SERVICEORDRE – 2013-1

HENVISNING:	United Parachute Technologies og FNLFSO 2009-1
FORMÅL:	Modifisere staging loop som skal holde freebag på plass i container.
STATUS:	Obligatorisk ved neste hovedkontroll for rigger produsert av UPT.
IDENTIFIKASJON:	Alle rigger (sports- elev- og tandemrigger) produsert av UPT med staging loop.
BAKGRUNN:	Det vises til SO 2009-1 der det skulle monteres staging loop som hadde til hensikt å holde freebag på plass. Modifiseringen var obligatorisk på elev- og tandemutstyr samt frivillig på sportsutstyr. Det er på enkelte rigger funnet slitasje på loopen under stoppskiven.
SERVICE:	Vektor Sigma tandem-, elev- og sportsutstyr med staging loop skal modifiseres i henhold til UPT sin servicebulletin. Det gjøres ved å fjerne stoppskiven og knyte dobbeltknote på loopen. Se vedlagte instruksjoner.
UTFØRELSE:	Alle UPT produserte rigger med staging loop skal modifiseres ved første hovedkontroll. Modifikasjonen utføres av MK/MR. Når modifikasjonen er utført merkes kontrollkortet med SO 2013-1 gjennomført.

SERVICE BULLETIN #20121106

SUBJECT: "Reserve Staging Loop" with support washer. We (manufacturer) require the washer be removed. At the next scheduled repack cyc

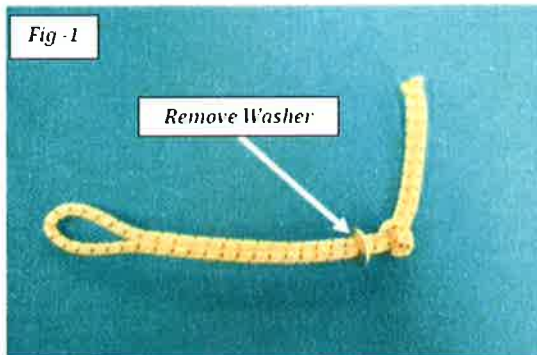
SERVICE BULLETIN: At the next scheduled inspection/repack cycle remove the support washer from the "Reserve Staging Loop." (Fig-1) Inspect the internal and external condition of the staging loop and replace it if any damage is found. Tie a "Double Over-Hand Knot" at the prescribed location. The staging loop length should be 1-inch (25mm) shorter than the reserve closing loop. Mark the loop at the desired length. Fig-2 shows a single over-hand knot. Fig-3 shows the loop end passing one more time through to create the double
